Decision **PROPOSED DECISION OF COMMISSIONER CHONG**  
(Mailed 8/15/2008)

**BEFORE THE PUBLIC UTILITIES COMMISSION OF THE STATE OF CALIFORNIA**

Rulemaking 07-12-001  
(Filed December 6, 2007)

**DECISION ADOPTING UNIFORM CONSTRUCTION  
STANDARDS FOR POLE-TOP ANTENNAS**

~~Figure 94.1~~

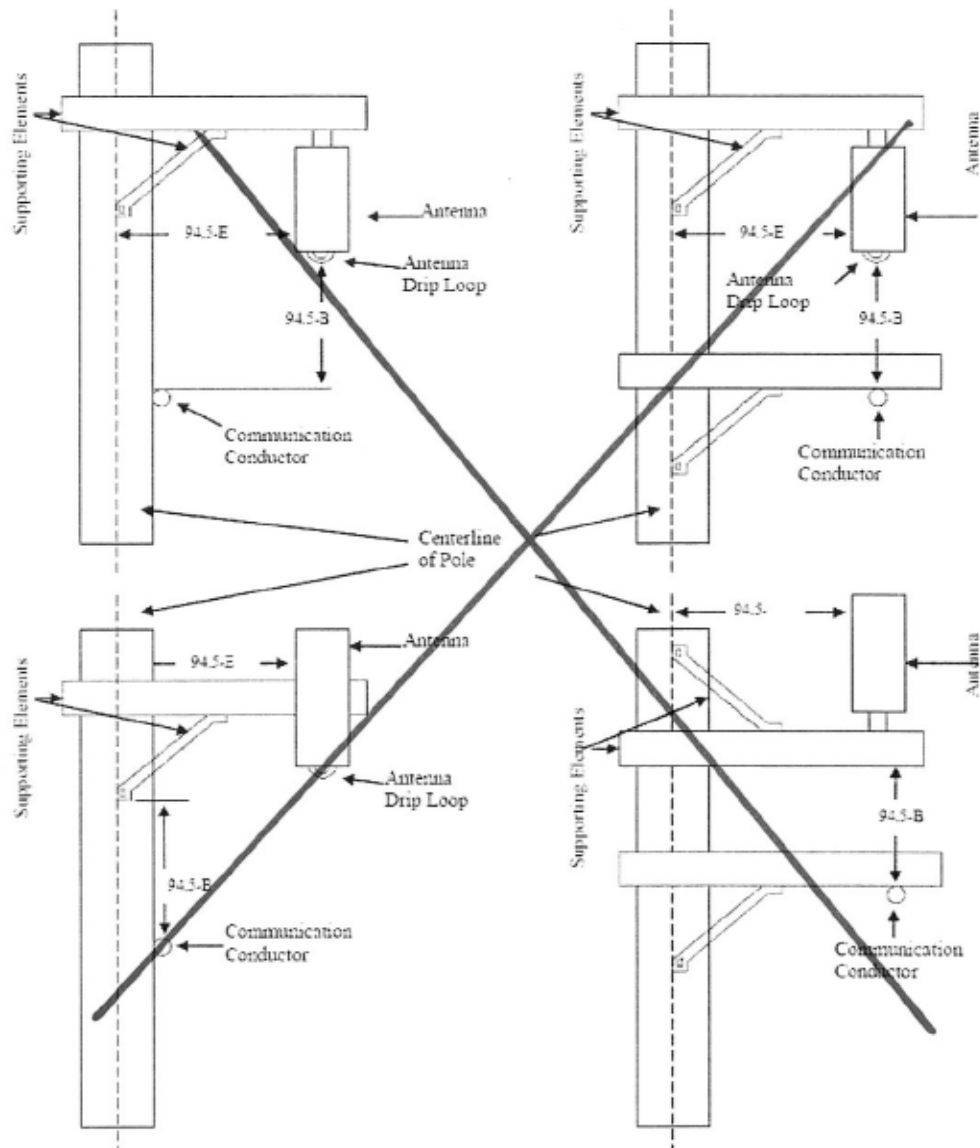
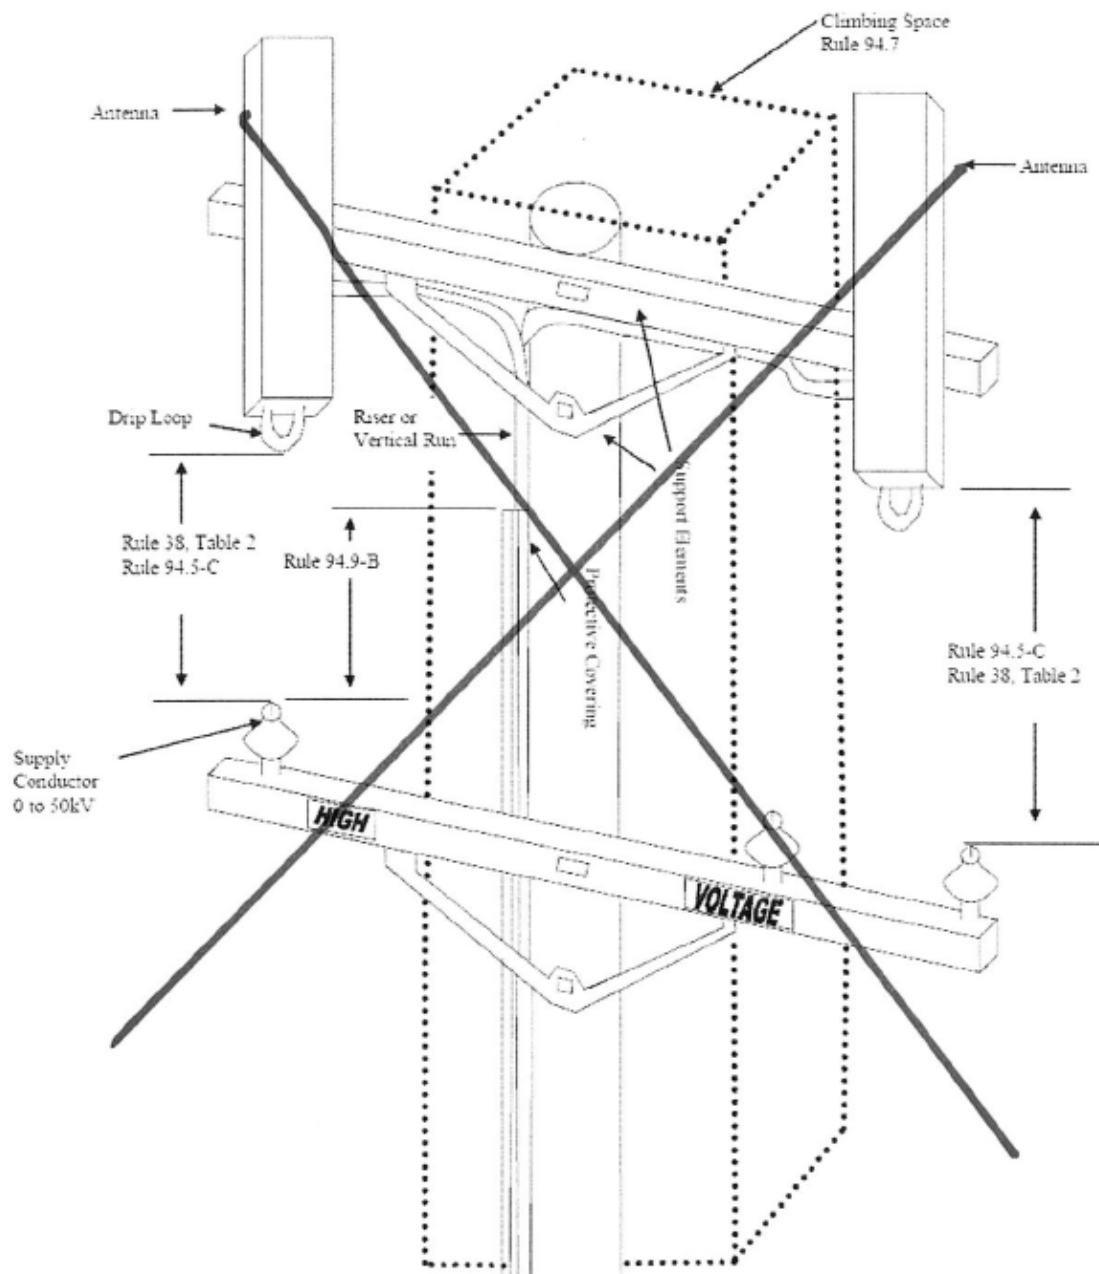
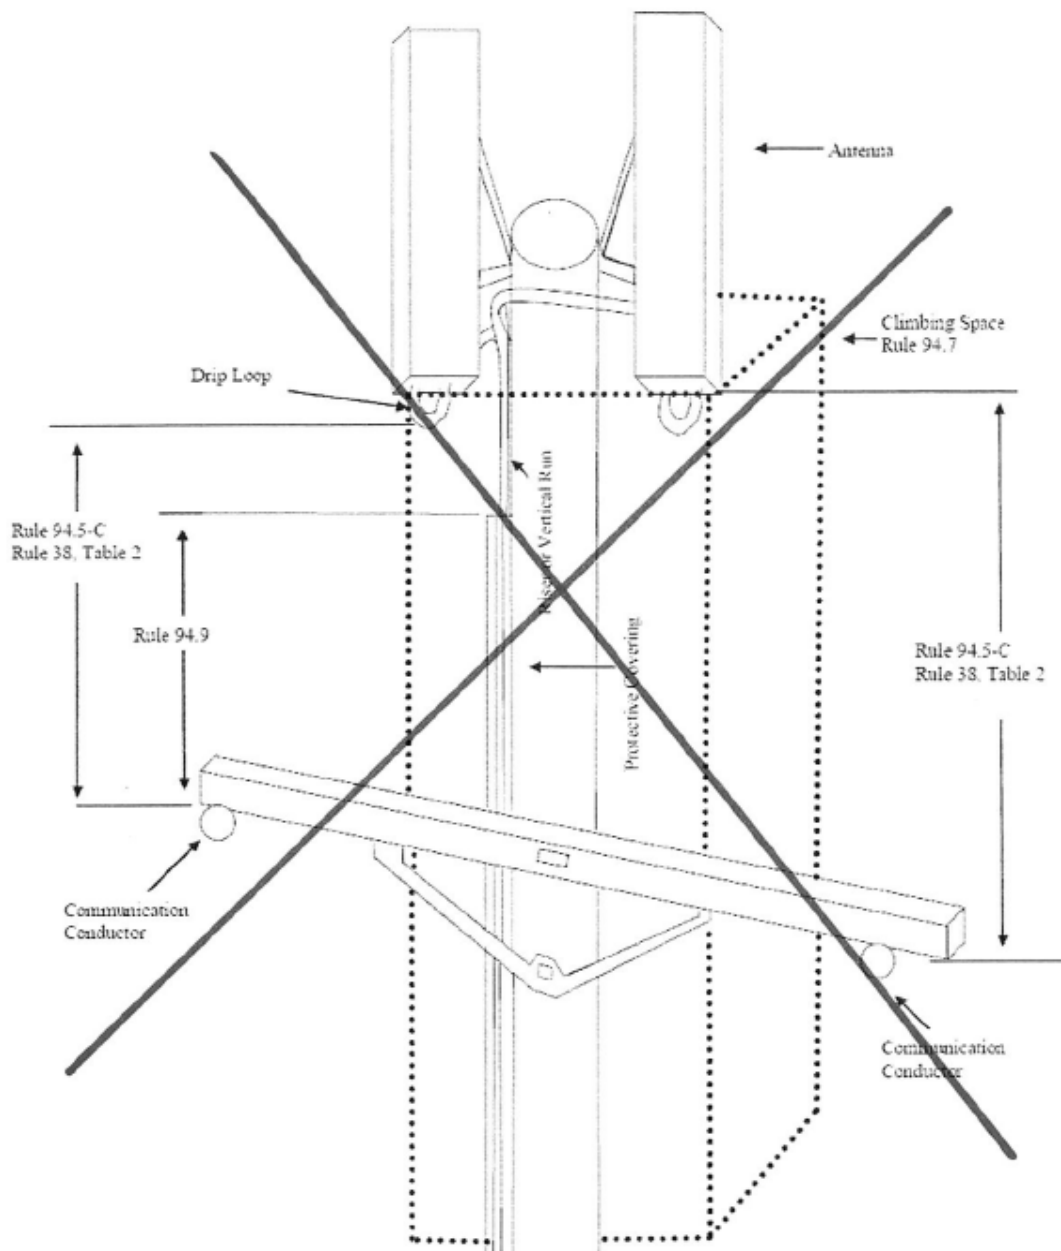
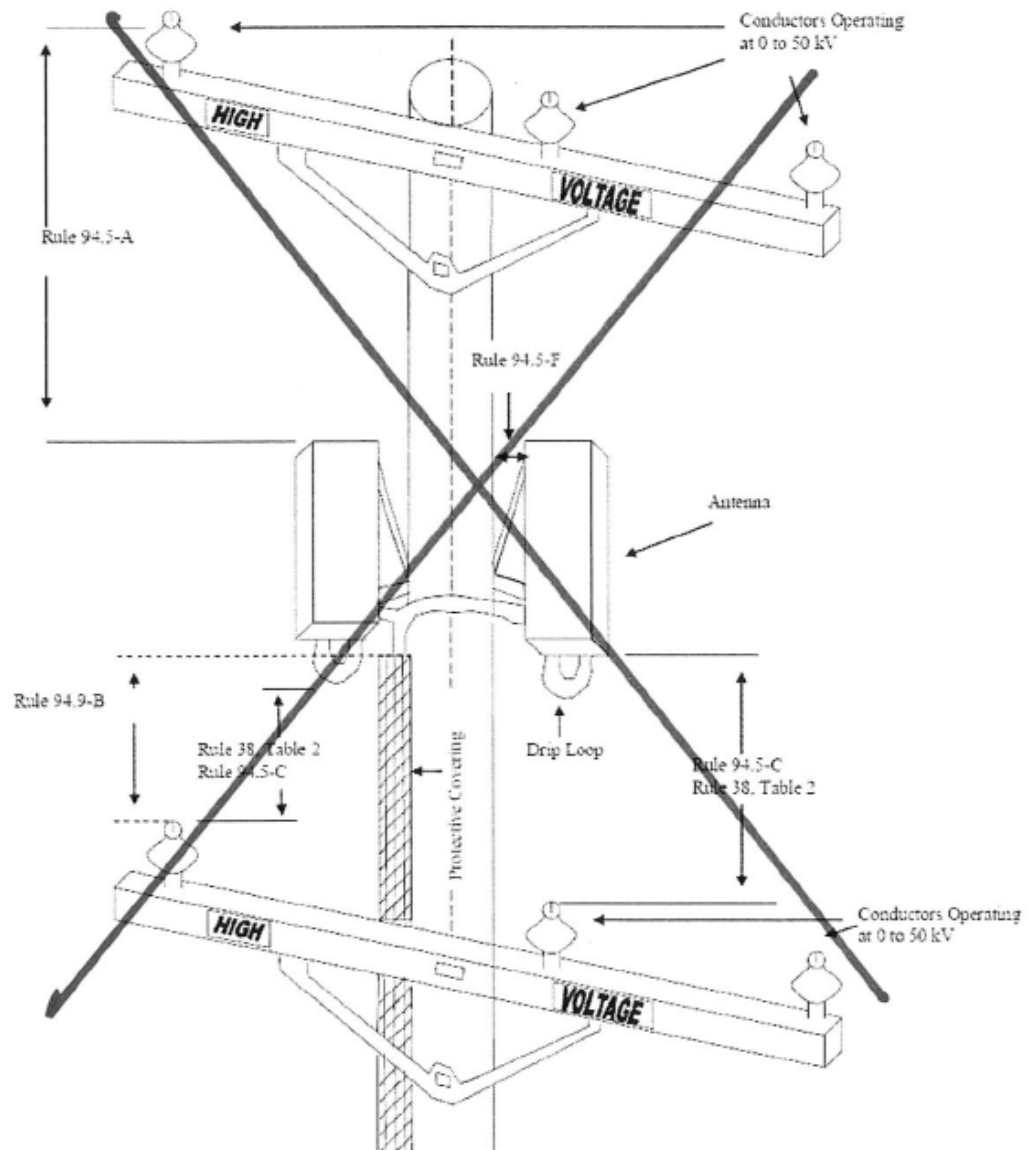
Also, the references to multiple Figures (94.1 – 94.5) were replaced with references to a new composite Figure 94.1.

**New 94.6:** Renumbered from (original) 94.7, a reference to (original) Figure 94.3 was also removed as parties agreed this reference was no longer needed.

Figure 94-1

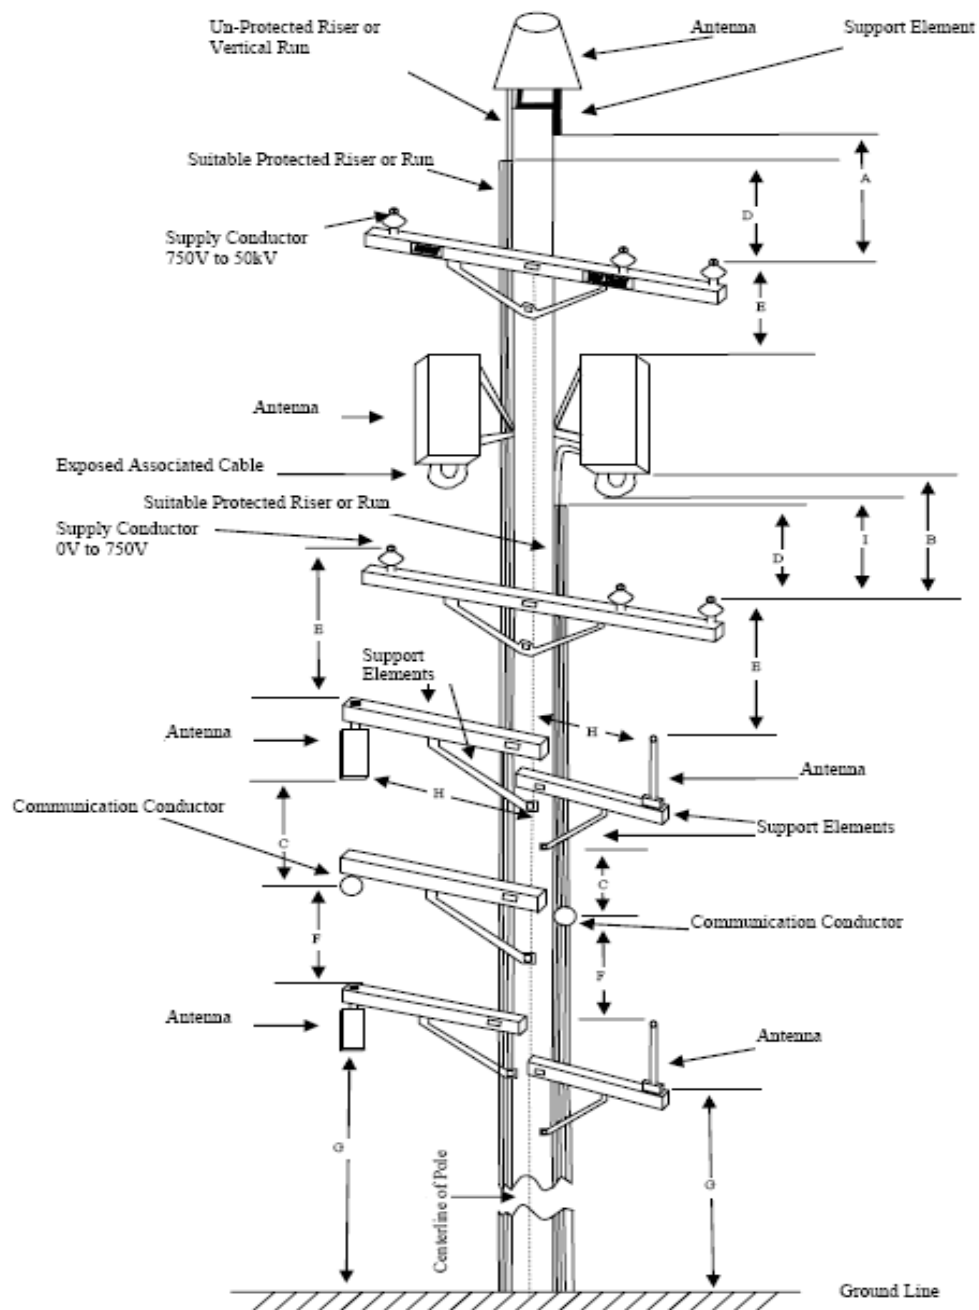
Finally, the TCR proposes to replace four existing diagrams with one new diagram labeled Figure 94.1. The new diagram illustrates in one place all of the vertical and horizontal clearances mandated by the revised Rule 94.

During the afternoon session, attendees discussed revisions to Figures 94.1 – 94.5 and concluded that a new Figure that encapsulates the variety of wireless antenna installations above and below supply and communication lines on a joint-use utility pole would be preferable to five separate Figures.

- A.** Antennas and support elements below supply lines shall maintain a vertical clearance of 6 feet from Supply Conductors operating at 0 –50kV. (See Figure 94-1)
- B.** Antennas and support elements below communication lines shall maintain a 2 ft. vertical separation from communication conductors and equipment. (See Figure 94-1)
- C.** Antennas, associated equipment (e.g. terminations, enclosures) and support elements installed above supply lines and/or communication lines of different ownership attached to the same structure shall maintain the vertical clearances specified in Rule 38, Table 2, Case 21, Columns A - H.

- D.** Antennas, associated equipment (e.g. terminations, enclosures) and support elements, installed above supply lines and/or communication lines of different ownership, shall maintain the radial clearances from unattached supply and communication lines specified in Rule 38, Table 2, Case 3.
- E.** Antennas shall maintain a 2 ft. horizontal clearance from centerline of pole when affixed between supply and communication lines or below communication lines. (See Figure 94-1)

- F.** Horizontal clearances from centerline of the pole for Antennas, associated equipment and support elements, affixed between supply lines or at the top of a climbable pole, are not specified, but must be arranged so that the pole may be climbed safely.
- G.** Antennas shall have a vertical clearance above ground as specified in Rule 37, Table 1, Column B, Cases 1 - 6a. (See Figure 94-1)
